BAR Meeting
September 15, 2010

ISSUE: Permit to Demolish/Encapsulate and Addition/Alterations
APPLICANT: Neil and Ruth McCray by Adams Architects (Scot McBroom)
LOCATION: 620 South Saint Asaph Street
ZONE: RM / Residential

BAR CASE #2010-0235/0236 09/15/2010

Figure 1. Early scheme of proposed addition.

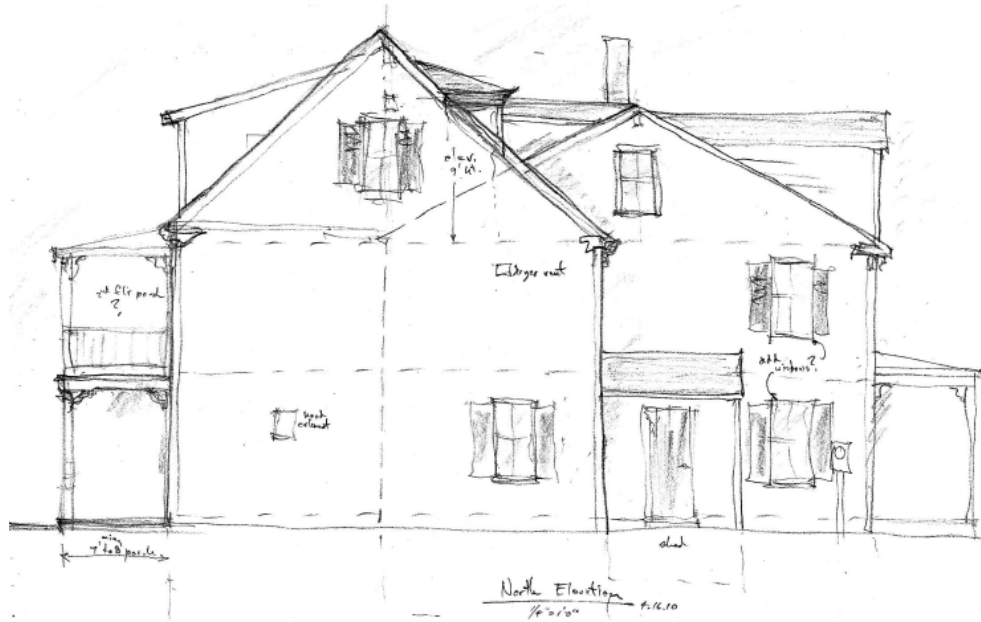
Staff met with the applicant several times prior to the filing of this submission to review and refine the design. An initial scheme included a rear gable form with a higher roof ridge than the historic block. The massing of the rear addition in this early scheme (below) overwhelmed the historic main block and was strongly discouraged by staff.

In addition, revising the rear portion so that the rear gable ridge was no higher than the gable ridge on the main block allows the addition to be secondary to the historic block. While the proposed addition is substantial, the massing and scale are both appropriate. Contextually, the addition will be adjacent to a three-story house and the height of the tower, *not the addition*, will be just above the roof of the neighboring house at 618 South St Asaph Street. In addition, as the streetview photographs show, the addition will be minimally visible from South St Asaph Street due to the location at the rear of the main block. The architectural side elevations that were submitted are views that will never be visible in this form because of adjacent buildings. As a practical matter, substantial screening vegetation is also present through much of the year. Staff suggests that the location of the proposed tower is much like the tower bay on the south side of the residence at 505 S. Lee Street and should have a similar visual relationship to the streetscape.

Figure 2. Early scheme showing initial tower proposal.

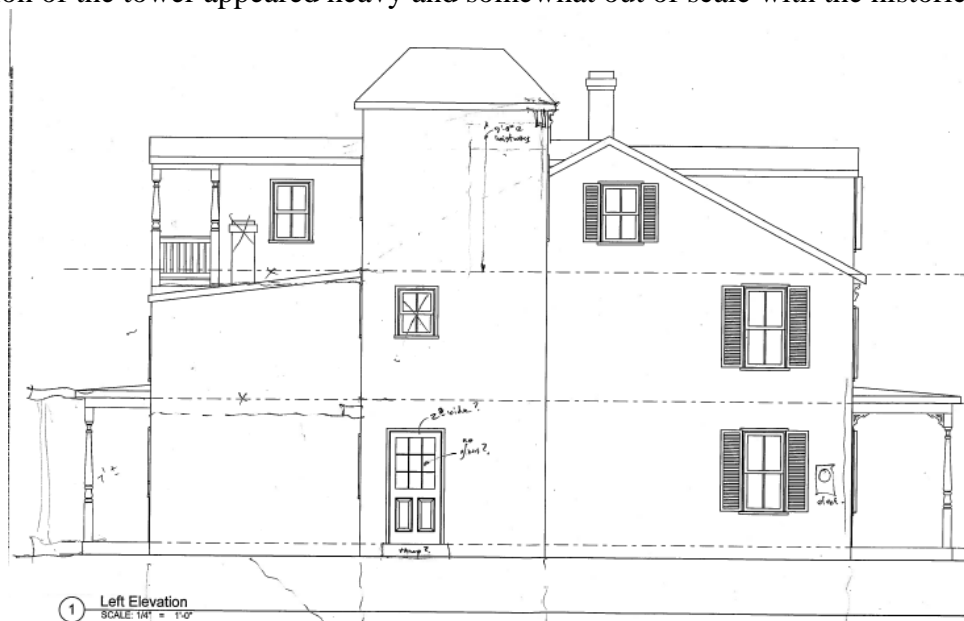
Another early scheme featured a tower element as a way to accommodate an elevator shaft. This early version of the tower appeared heavy and somewhat out of scale with the historic house.

However, the use of a tower, a design element often associated with Queen Anne architecture, was found to be a historically appropriate way to accommodate the modern needs of an elevator. Although a tower would not be appropriate on many houses in the district, this proposal is an exception as this building is one of very few freestanding Queen Anne style houses. However, the location of the tower at the rear of the historic main block will ensure that it does not overwhelm the streetscape or the existing house. The refinement of the tower and the incorporation of design details found on the historic house, such as the brackets and cornice, have resulted in a uniquely appropriate and compatible design.

Figure 7. Existing side (south) elevation also indicating massing of proposed addition and areas of demolition/encapsulation.

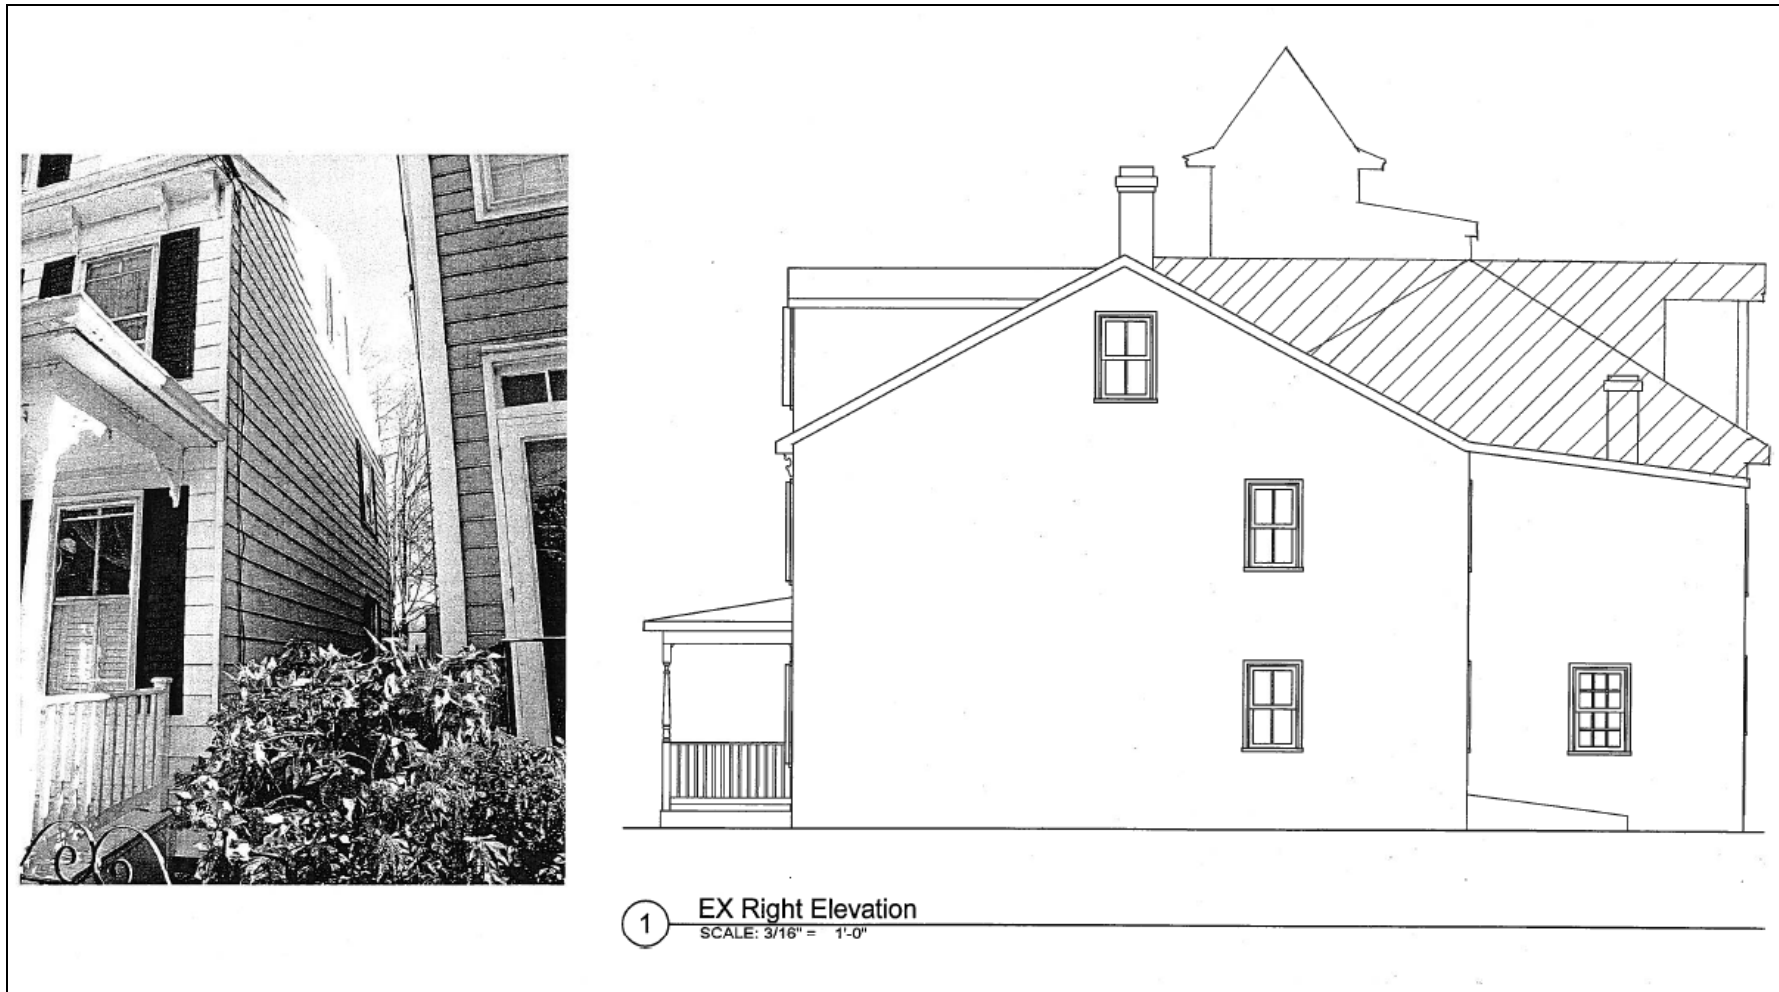
- 4.2 square feet to be demolished for enlarged window opening

On the south elevation the applicant proposes to enlarge an existing window in the rear block.

Figure 8. Existing rear (east) elevation, showing massing of proposed addition and areas of demolition/encapsulation.

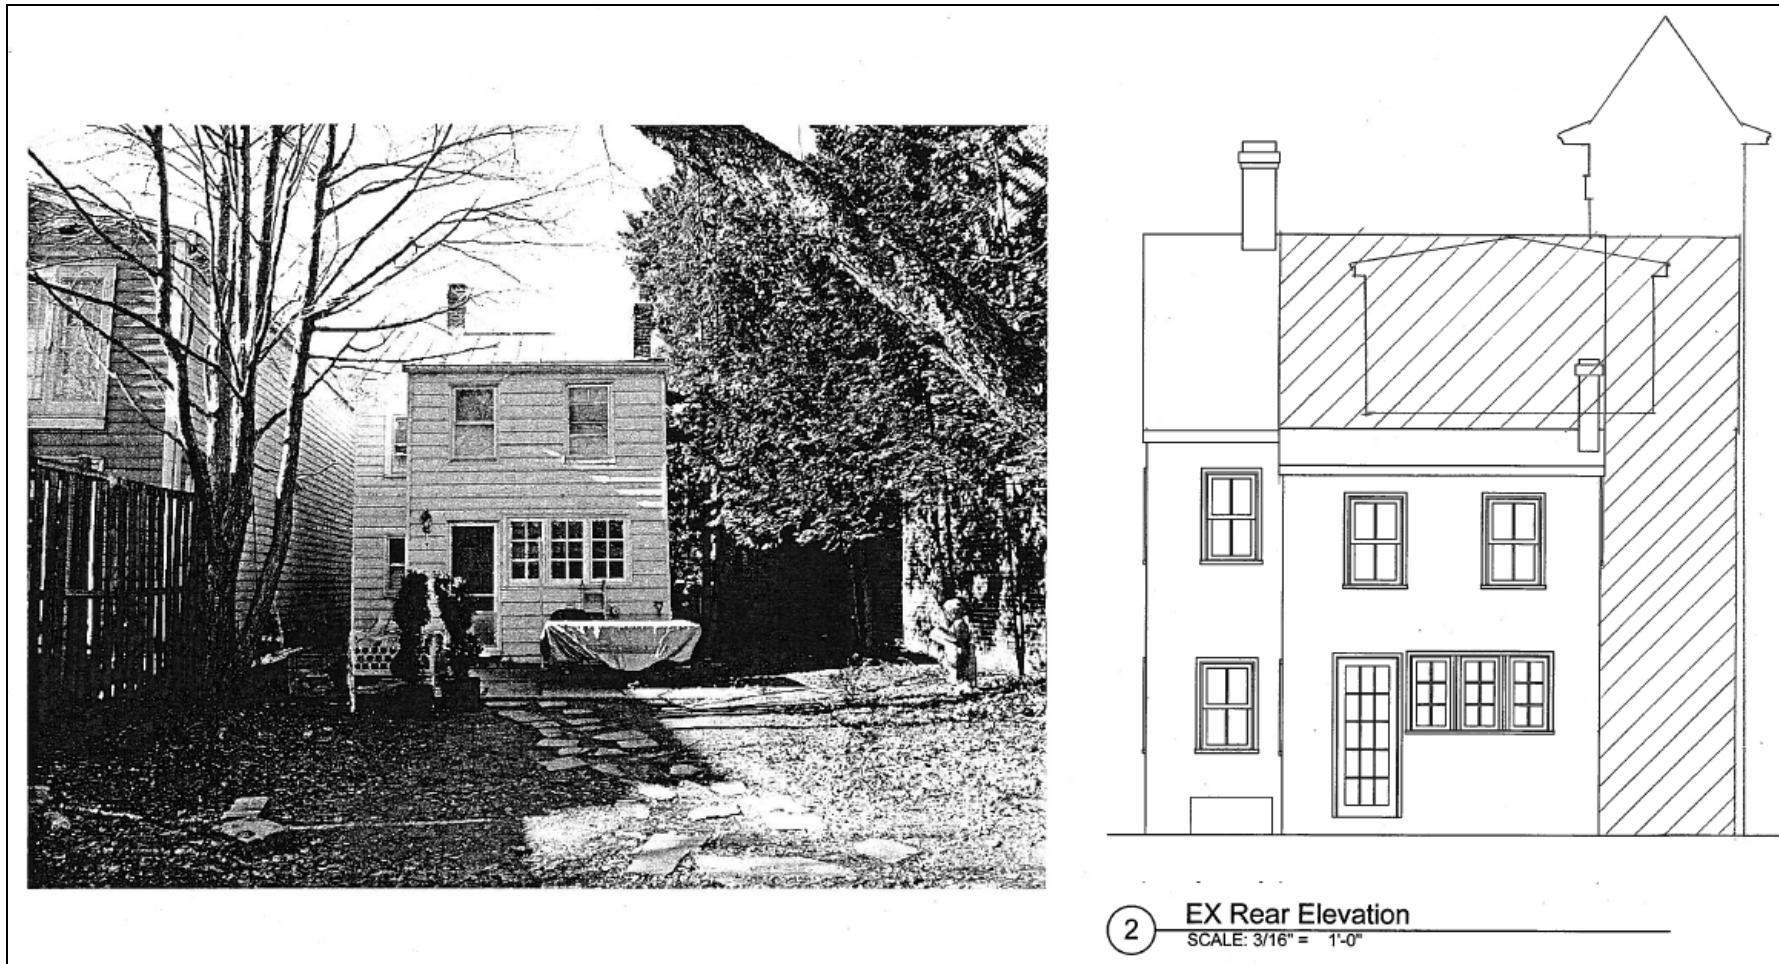
East Elevation:

- 15 square feet to be encapsulated
- 38.5 square feet to be demolished

Staff has no objection to the proposed encapsulation and demolition of portions of the north (side) and east (rear) elevations and the roof of the existing rear block (including demolition of the flue), and finds the proposed addition to be compatible with the existing building and surrounding area.
